# INDIANA DEPARTMENT OF TRANSPORTATION

## Design Memorandum No. 12-12 Technical Advisory

**SUBJECT:** Reinforced-Concrete Bridge Approach

**SUPERSEDES:** *Indiana Design Manual Section 17-5.09*

### RCBA THICKNESS DETERMINATION

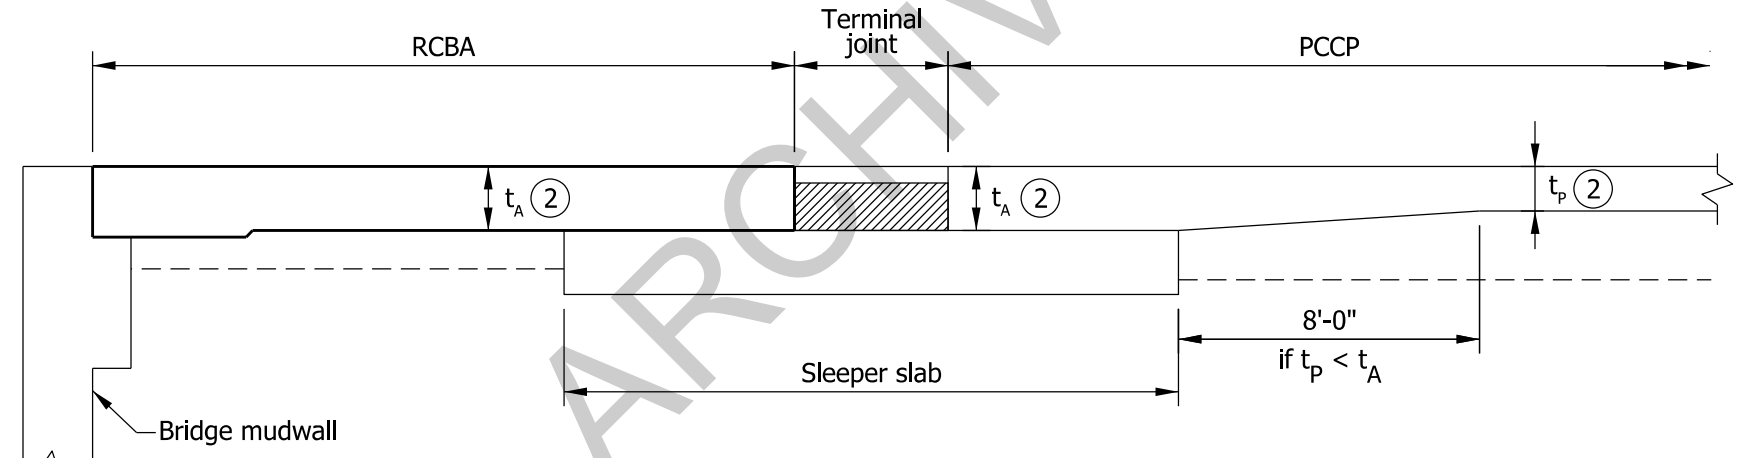
(2) If  $t_p \geq 12$  in.,  $t_A = t_p$ .  
If  $t_p < 12$  in.,  $t_A = 12$  in.
